CITY OF LA VISTA
MAYOR AND CITY COUNCIL REPORT
JULY 19, 2016 AGENDA

Subject:	Type:	Submitted By:
APPLICATION FOR PRELIMINARY PLAT, LOTS 1-7, BRENTWOOD CROSSING, LOTS 8B & 8C, BRENTWOOD CROSSING REPLAT NO. 1, LOTS 8A1, 8A2, 8A3 & 8A4, BRENTWOOD CROSSING REPLAT NO. 2, AND PORTIONS OF TAX LOT 12, 14-14-12; AND WAIVER OF SECTION 4.24, SUBDIVISION REGULATIONS (SE OF 84 TH & SUMMER DR.)	◆ RESOLUTION ORDINANCE RECEIVE/FILE	ANN BIRCH COMMUNITY DEVELOPMENT DIRECTOR

RE: Preliminary Plat – Initial Review
La Vista City Centre

RE: Preliminary Plat – 2nd Review
La Vista City Centre

SHEET
C3.1

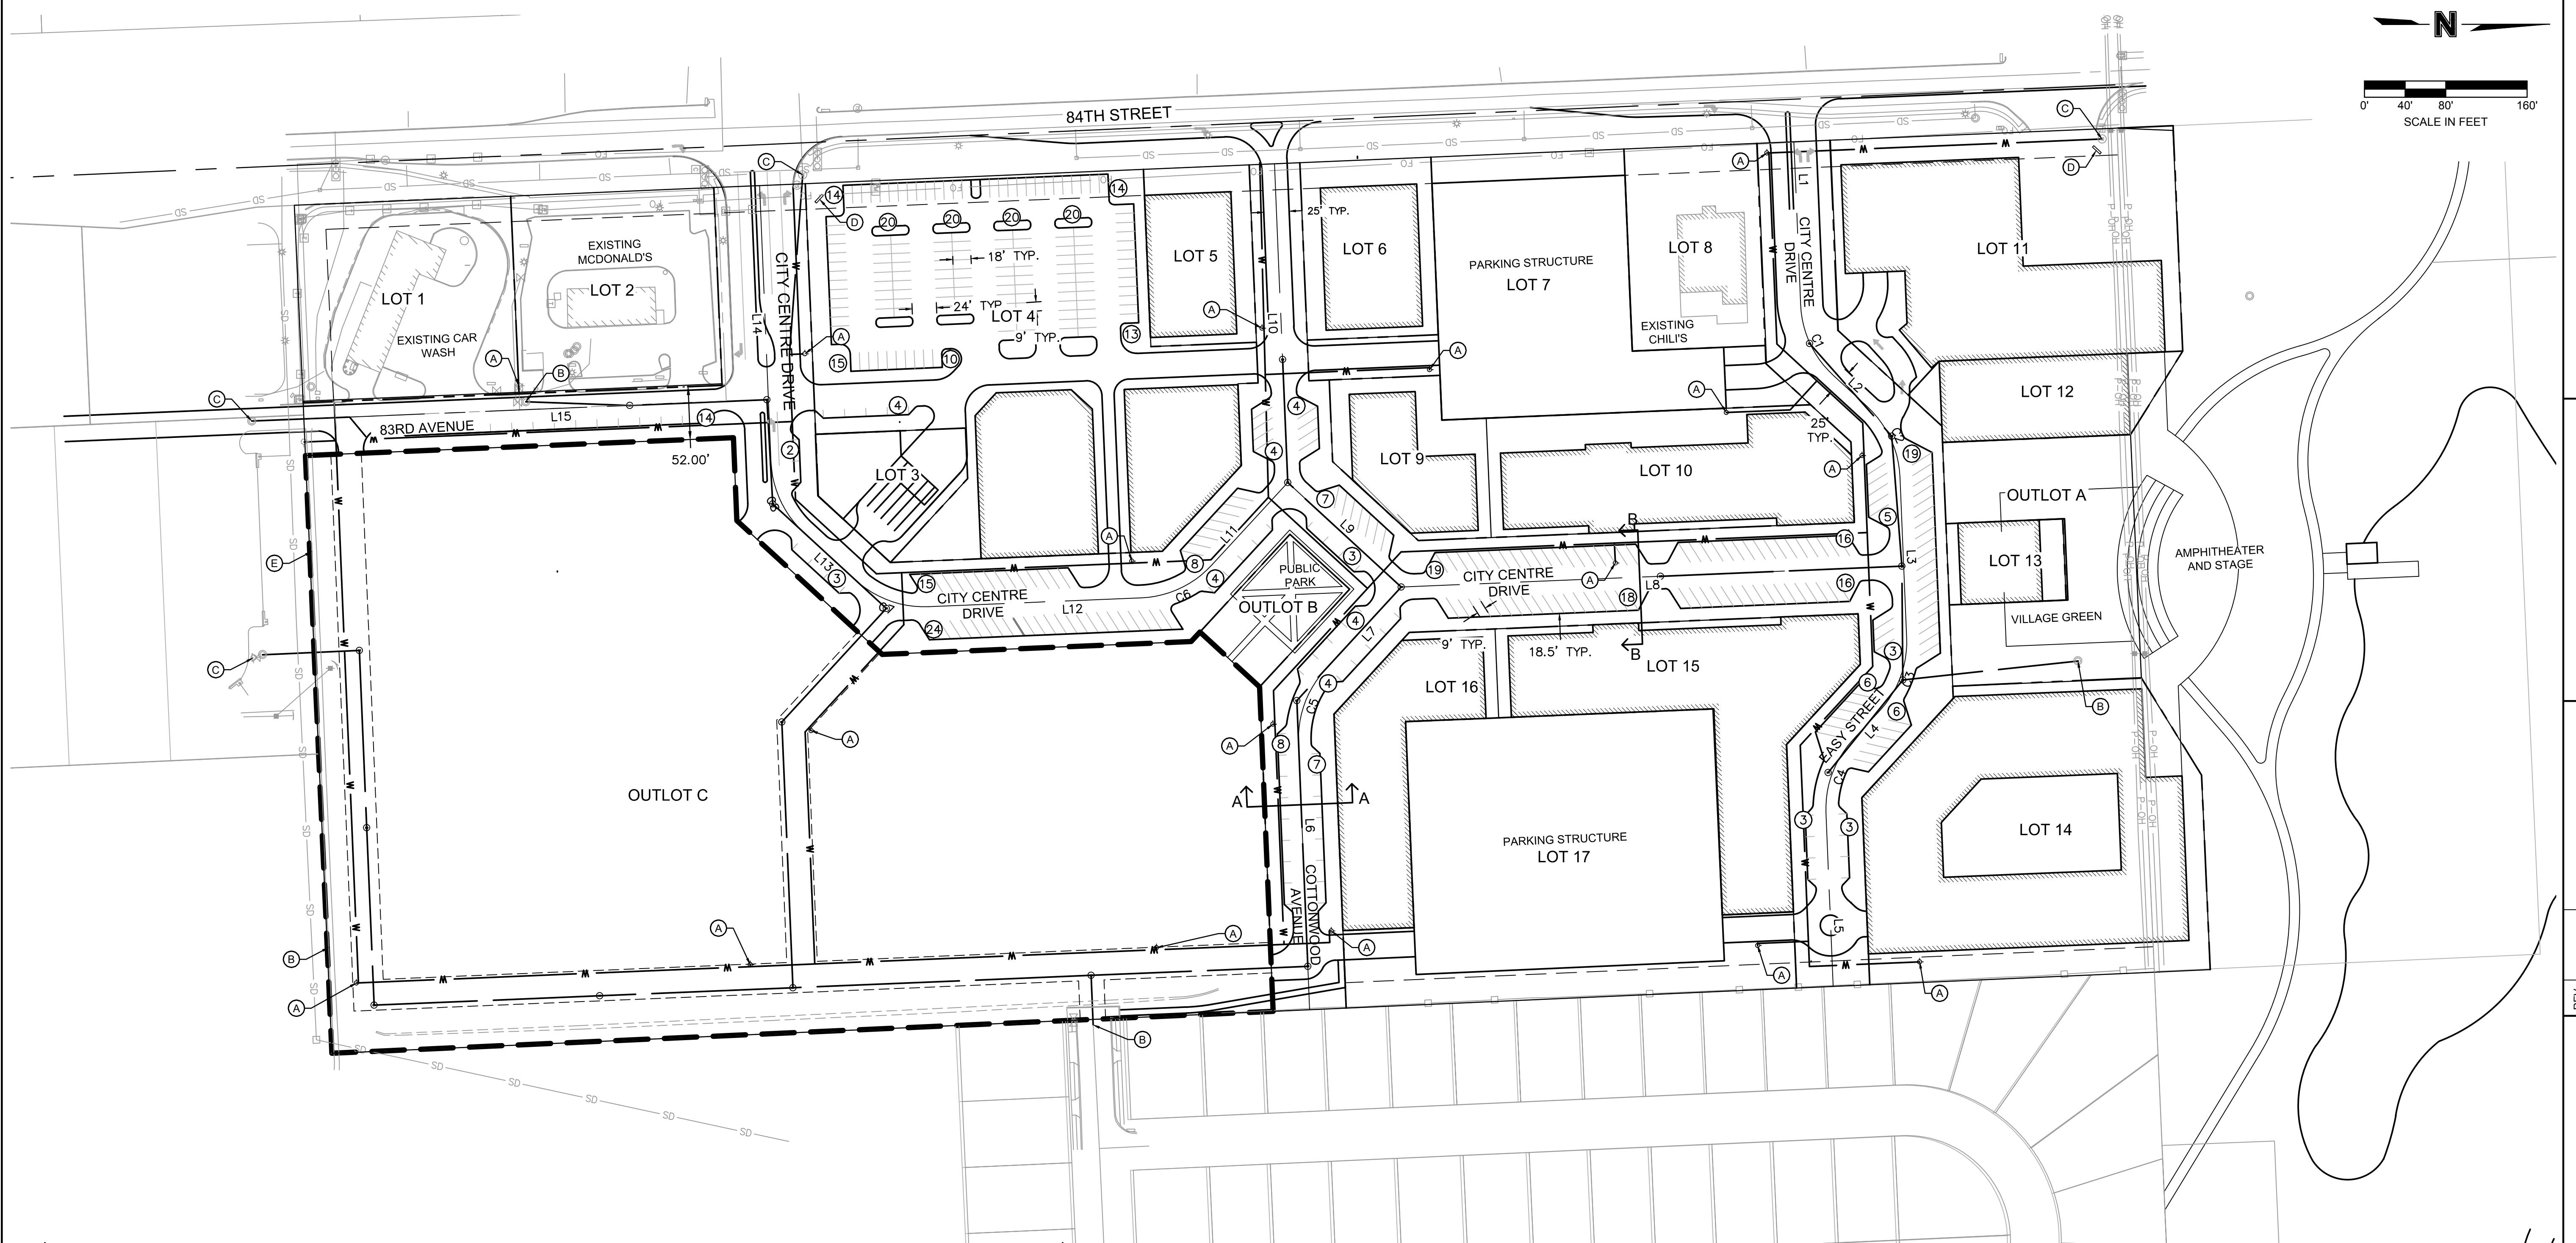
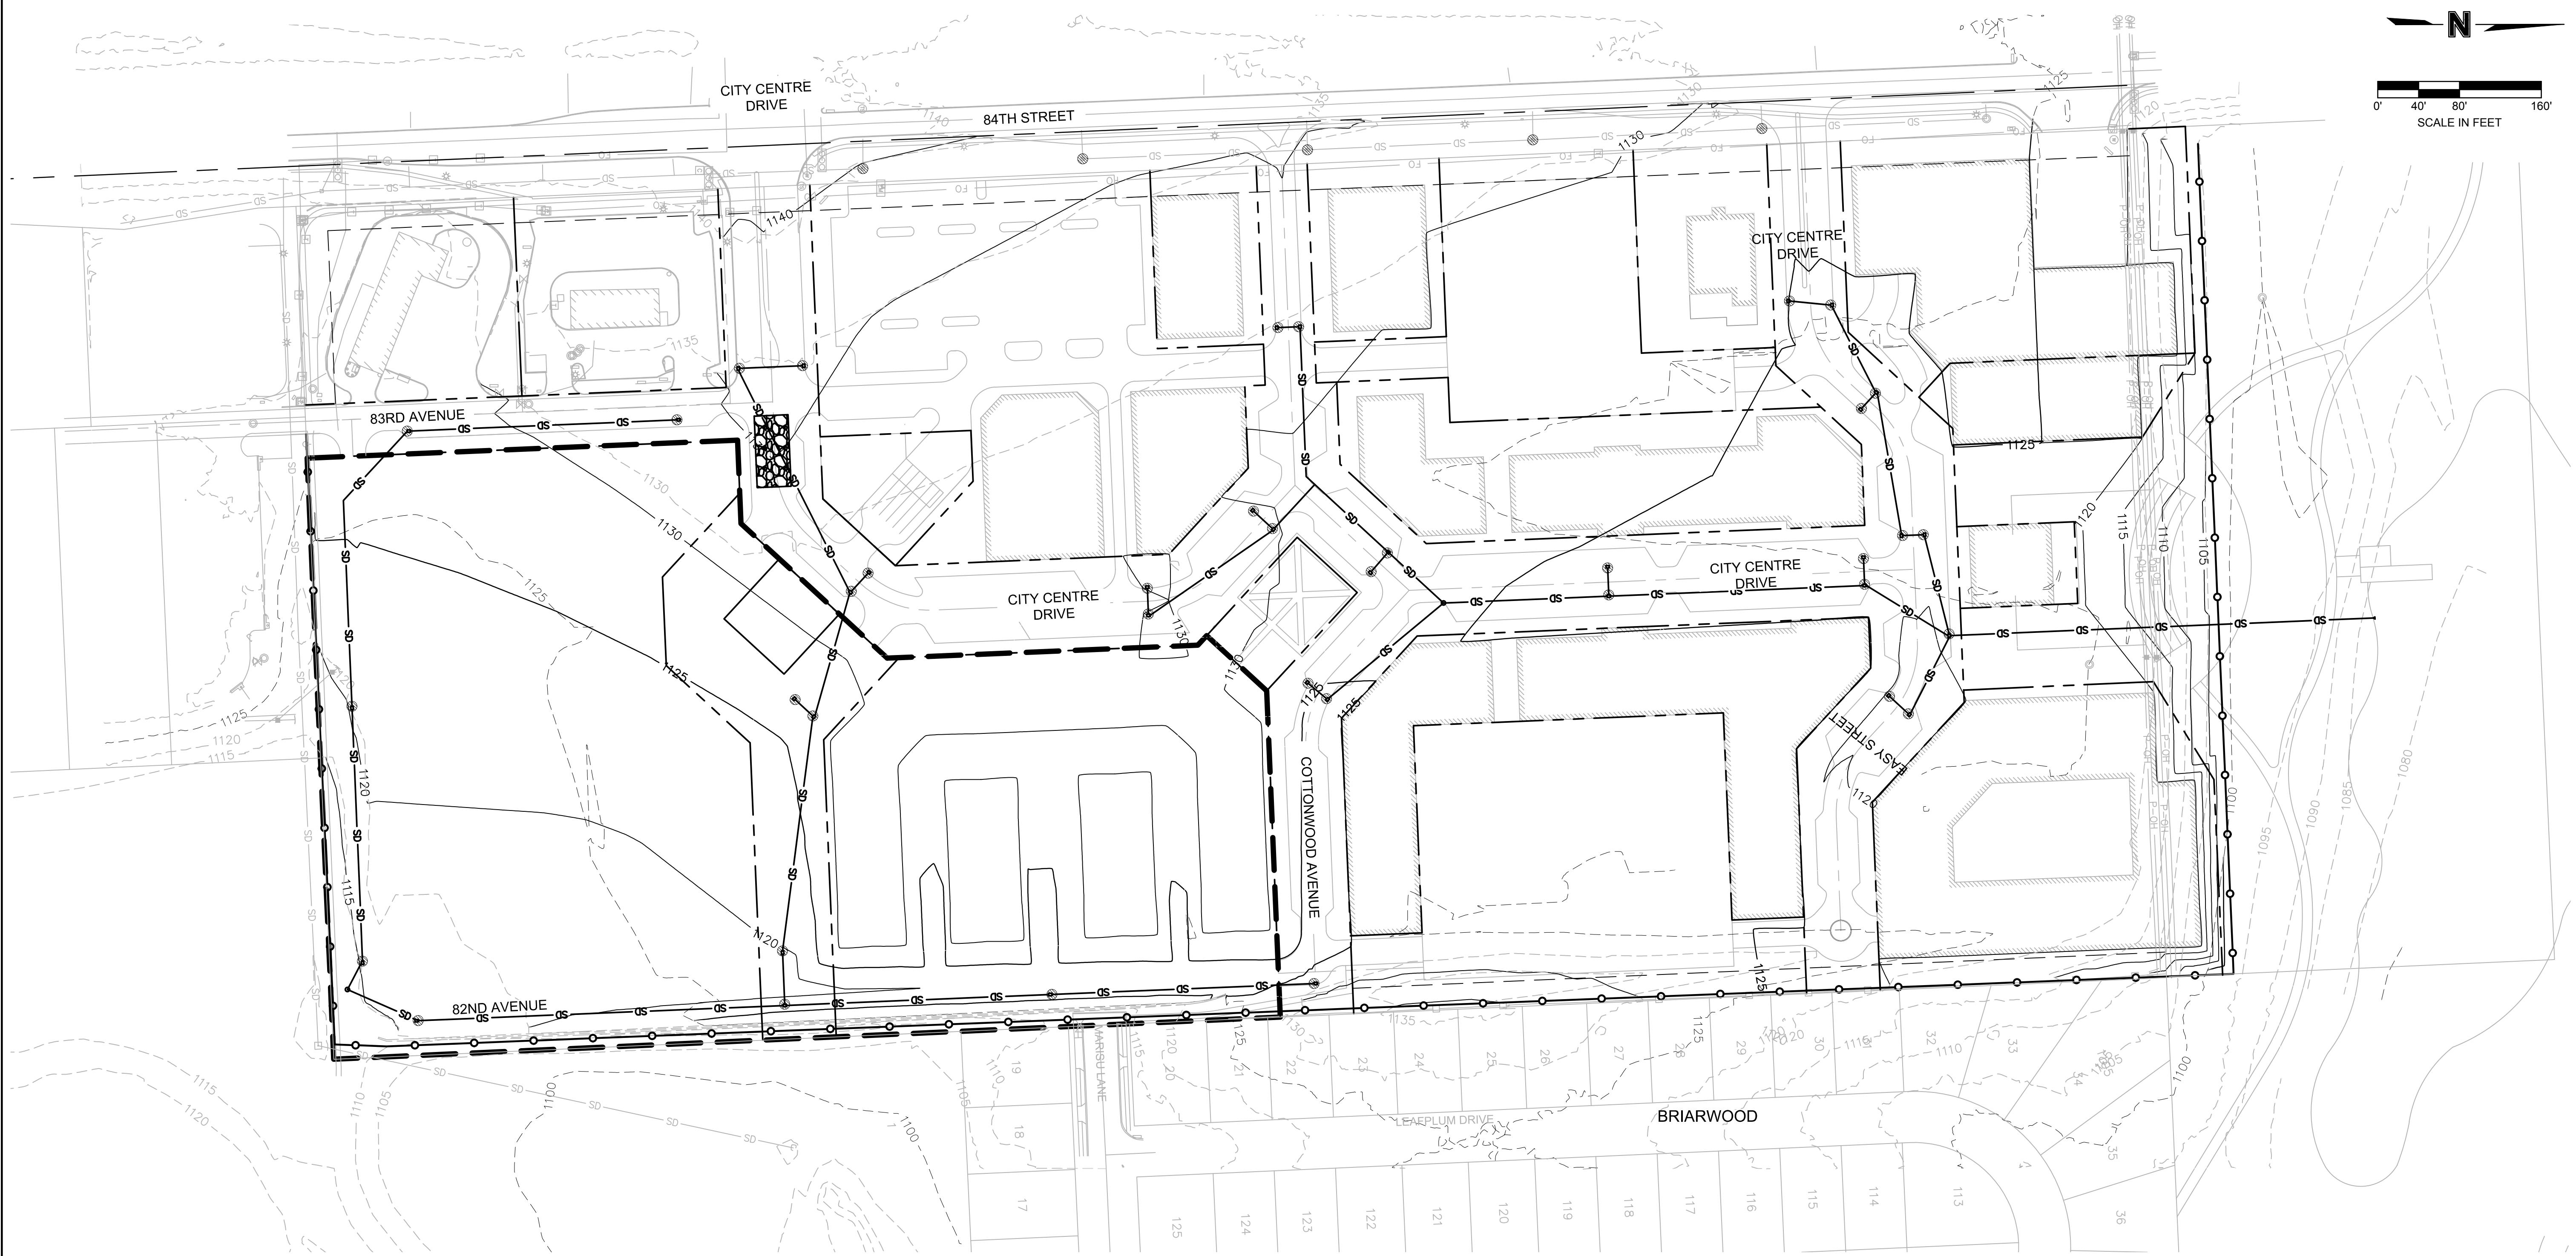
15. The proposed pavement type and thickness needs to be noted on Sheet C3.1 in the typical sections. This is needed per Article 3.03.20(3) of the Subdivision Regulations.

18. Note 1 on Sheet C3.1 indicates gas to be provided by MUD. Gas will be provided by Black Hills Energy.
19. The existing Chili's configuration on proposed Lot 7 should be shown as we understand that facility is to remain in its current configuration. The manner in which that will be incorporated into the project should be shown.

3. Itemized cost estimates for infrastructure improvements need to be provided per Article 3.03.15 of the Subdivision Regulations.
4. The typical sections on Sheet C3.1 indicate pavement thickness of 7 inches. Section 4.24 of the Subdivision Regulations indicates minimum pavement thicknesses. The footnotes to the table in that section indicate a minimum of 8 inches for streets in commercially zoned areas. There should be a discussion with the applicant as to whether the drive aisles in the typical sections could be 8 inches thick and the parking stalls could be 6 inches thick. If the streets remain at 7-inches thick, then a waiver request should be processed.

Response: Proposed pavement thicknesses have been noted per the City's subdivision regulations.

Response: The note has been updated

Response: The typical section pavement thickness has been increased to 8 inches per the Subdivision Regulations and preliminary geotechnical report. Parking stall pavement thickness has been set at 5 inches per the preliminary geotechnical report.
